[Docket No. NHTSA-2008-0068]

Federal Motor Vehicle Safety Standards; Electronic Stability Control Systems; Controls and Displays

ACTION: Final rule; response to petitions for reconsideration.

Figure 1. Rotary Multi-mode Control Example

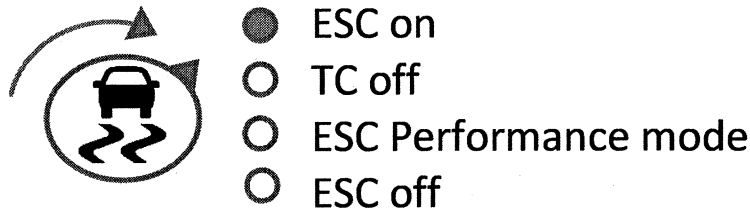
The Alliance/AIAM petitioned for clarification of paragraphs S5.4.2 and S5.4.3 regarding a control switch or button that combines several functions, which we will call a “multi-function” control for simplicity.¹⁴ For background, paragraph S5.4.2 requires that an ESC control whose only purpose is to disable the ESC system or place it in a mode in which it no longer satisfies the performance requirements¹⁵ be labeled either with the ESC symbol plus the word “Off” or the phrase “ESC Off.” The “ESC Off” telltale must also

illuminate when ESC is in a state in which it no longer satisfies the performance requirements. Paragraph S5.4.3 creates an exception for a control primarily for another function, such as a four-wheel drive low-range transfer case, that does not specifically control the ESC system directly, but has the ancillary effect of turning off ESC in low range. Such a control need not be labeled an “ESC Off” control, but the “ESC Off” telltale must still illuminate if ESC is put in a state in which it no longer satisfies the performance requirements.

The Alliance/AIAM offered the example of a multi-function control that could be used to turn ESC off or on, but could also be used to turn traction control off and to select an ESC “performance mode.” Because such a control could be seen as neither a control whose only purpose is to disable ESC, nor a control for another system with an ancillary effect, petitioners requested that the agency clarify that multi-function controls like the one described are not prohibited by FMVSS No. 126. Figure 1 below shows a rotary multi-function control (this example was provided in the petition).

Agency response: We are granting the petition to clarify S5.4.3, although we note that this question was already answered in the affirmative in the agency’s response to the GM request for interpretation. FMVSS No. 126 does not prohibit multi-function ESC controls that combine the control whose only purpose is to disable the ESC system with controls used for other purposes. Paragraph S5.4 specifically allows controls whose sole purpose is to disable ESC and establishes various requirements for them. The only reason that the standard distinguishes between these controls used only for disabling ESC from those used to control systems with an ancillary effect on ESC is to express the labeling requirements for the control symbols. The multi-function control example presented by the petition combines several controls in a single piece of hardware: one control whose only purpose is to disable ESC, one unregulated control for the traction control system, and another control that places the ESC system in an intermediate “sport” or “performance” mode.”

In the rotary multi-function control example of Figure 1, the function within the control that disables ESC, because its only purpose is to disable ESC,

would be required to be identified using the symbol or text specified in FMVSS No. 101 for “ESC Off” (effective September 1, 2011) on or adjacent to that part of the control. We would not consider the precise example given by the Alliance/AIAM petition as satisfying FMVSS No. 101’s requirement that the “ESC Off” label (“identifier”) be adjacent to the control it identifies, because the telltale lamp is located between the two.¹⁶ However, this problem could be solved by moving the lamp to the other side of the label.

FMVSS No. 126 does not specify requirements for the “TC off” function in the example, nor for the “ESC Performance mode” function, unless that function within the control places the ESC system in a mode in which it no longer satisfies the standard’s performance requirements. If it did, it would be considered an “ESC Off” control (because it is a control whose purpose is to place the ESC system in a mode in which it no longer satisfies the performance requirements) and would also have to be labeled accordingly.
